AIA® Document G731™ – 2019

Change Order, Construction Manager as Adviser Edition

PROJECT: *(name and address)*
Christian County High School

Access control modifications per PR #24. Window 40 revisions.

E6.4

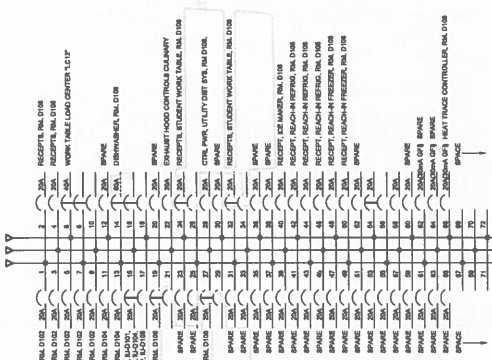
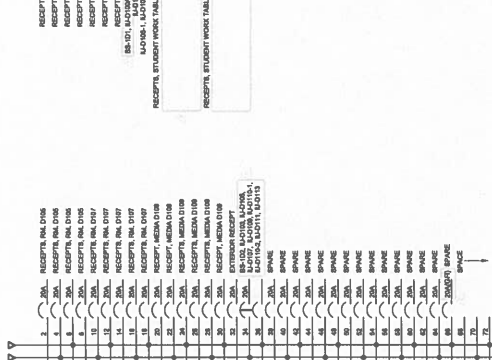
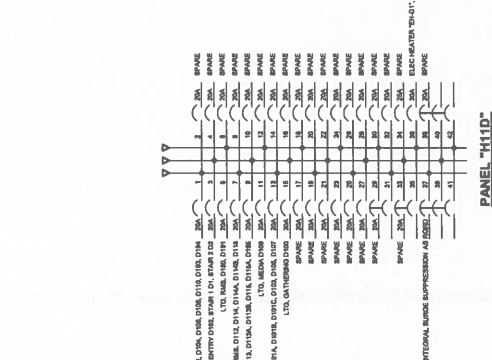
7. Reference Revised Drawings E2.1D Rev 3 & E6.4 Rev 4.
 - a. Corridor D100A. DELETE requirement to provide 120V power circuit to Power supply for door hardware (West End of corridor).

- b. Admin D101. DELETE requirement to provide 120V power circuit to Power supply for door hardware (Two doors).
8. Reference Revised Drawings E2.1E Rev 2 & E6.6 Rev 2.

E6.7

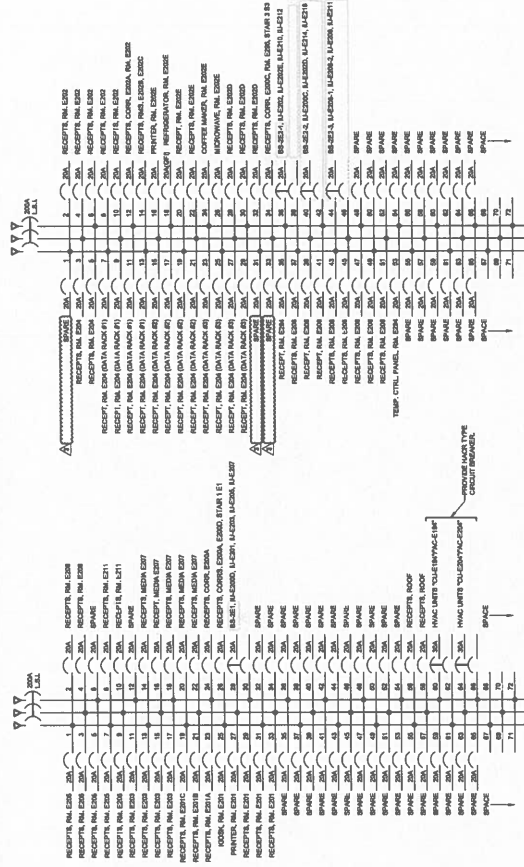
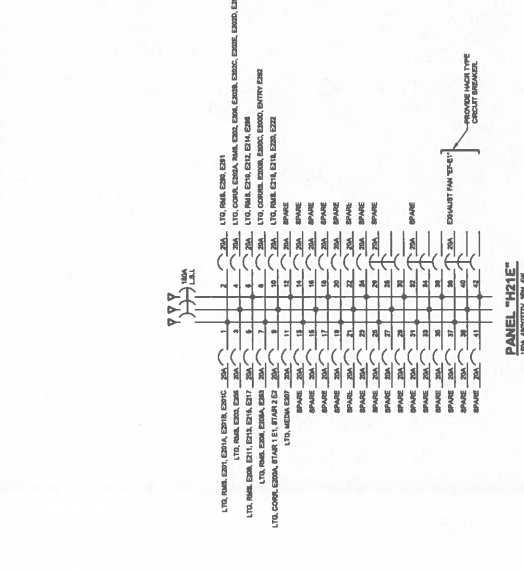
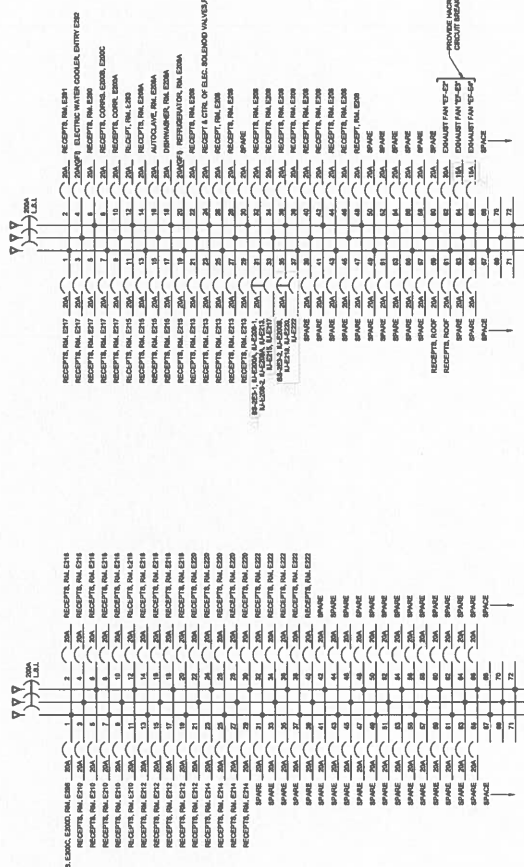
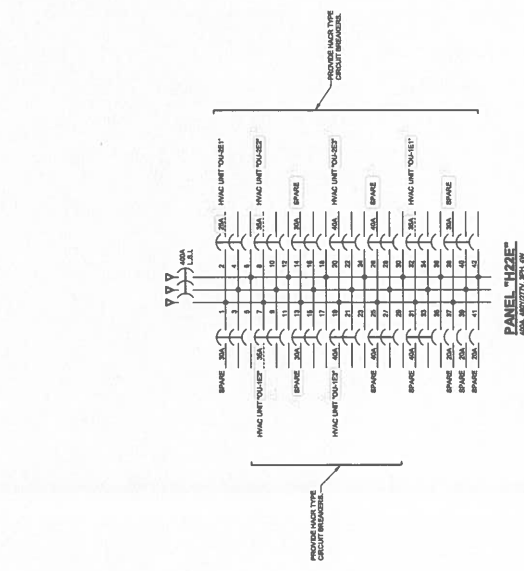
- b. Data Room D293. DELETE requirement to provide 120V power circuit to door hardware power supply.
15. Reference Revised Drawing E2.2E Rev 2 & E6.7 Rev 3.

E6.9

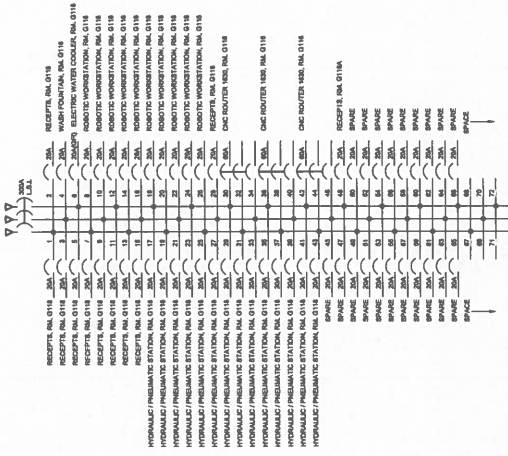
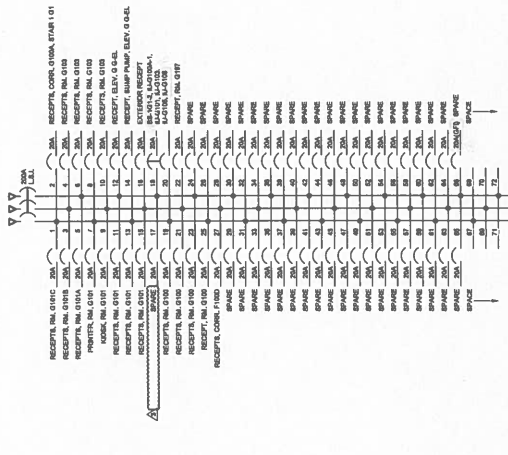
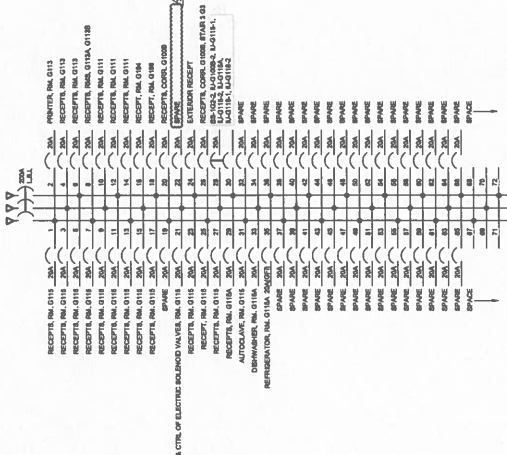
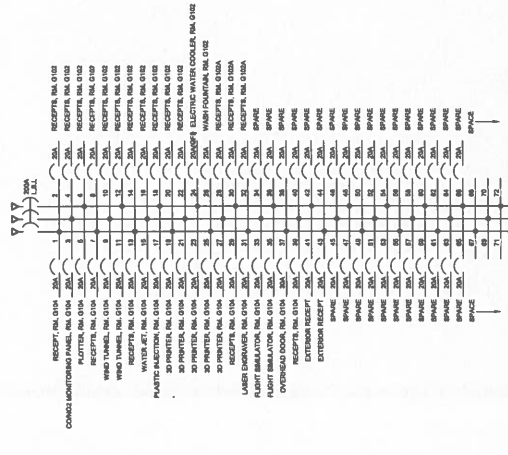
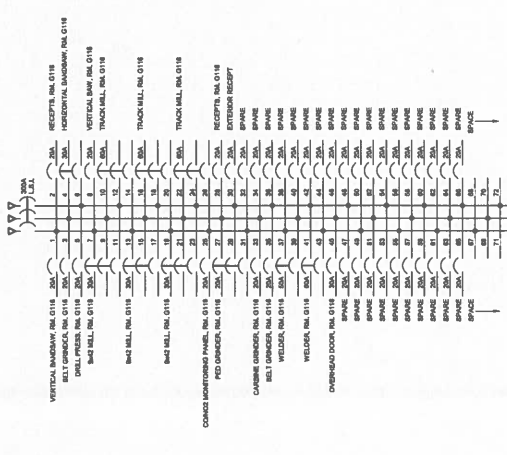
- b. Admin E101. DELETE requirement to provide 120V power circuit to Power supply for door hardware (Two doors).
9. Reference Revised Drawings E2.1F Rev 4, E6.9 Rev 3 & E6.14 Rev 1.

- c. Admin G101. DELETE requirement to provide 120V power circuit to Power supply for door hardware (Two doors).
10. Reference Revised Drawings E2.1G Rev 2 & E6.9 Rev 3.

- a. Corridor G100B. DELETE requirement to provide 120V power circuit to Power supply for door hardware (South End of corridor).
11. Reference Revised Drawings E2.1H Rev 3, E6.11 Rev 5, E6.12 Rev 2, E6.11 Rev 5, E6.17 Rev 3, & E7.3 Rev 3.

Drawing No:
E6.10

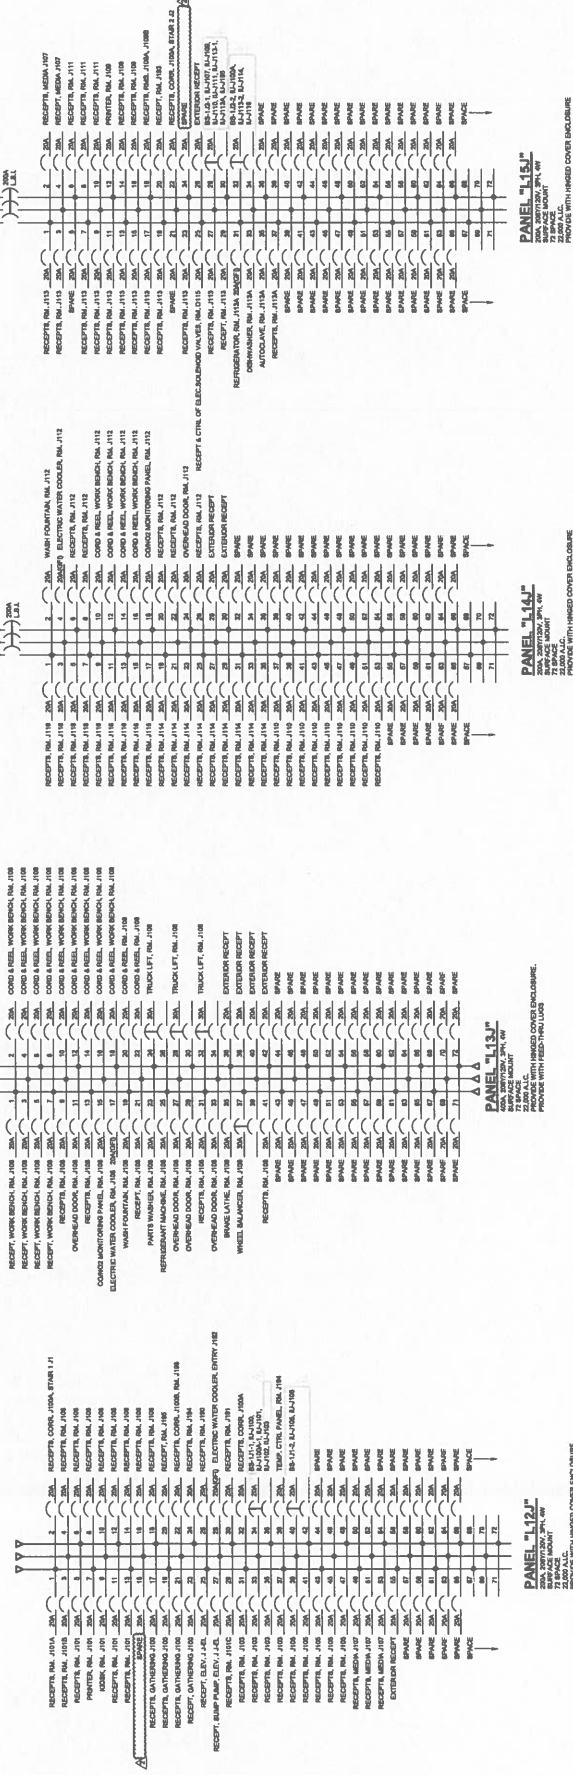
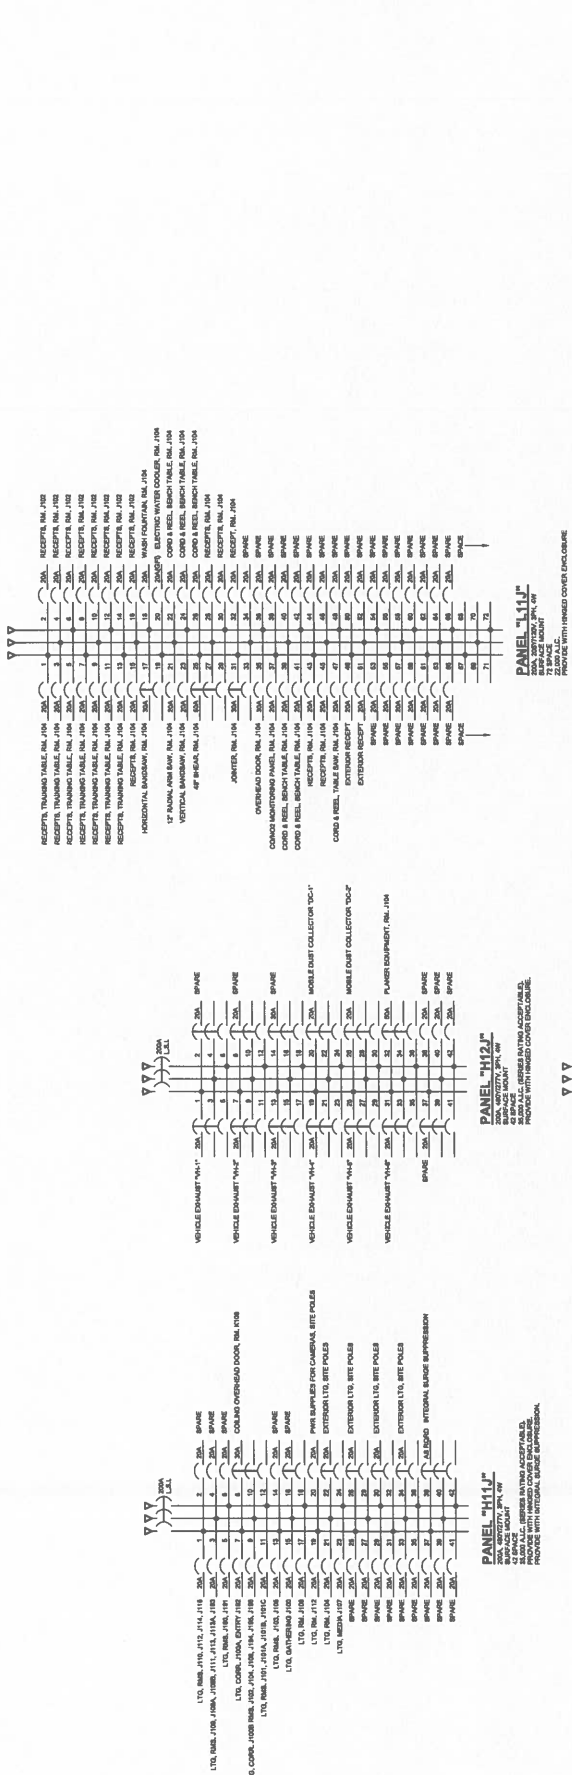
16. Reference Revised Drawings E2.2G Rev 2 & E6.10 Rev 3.
- a. Data Room G210. DELETE requirement to provide 120V power circuits (quantity two) to Access Control System panels.

- b. Data Room G210. DELETE requirement to provide 120V power circuit to door hardware power supply.
17. Reference Revised Drawings E2.2J Rev 2 & E6.13 Rev 4
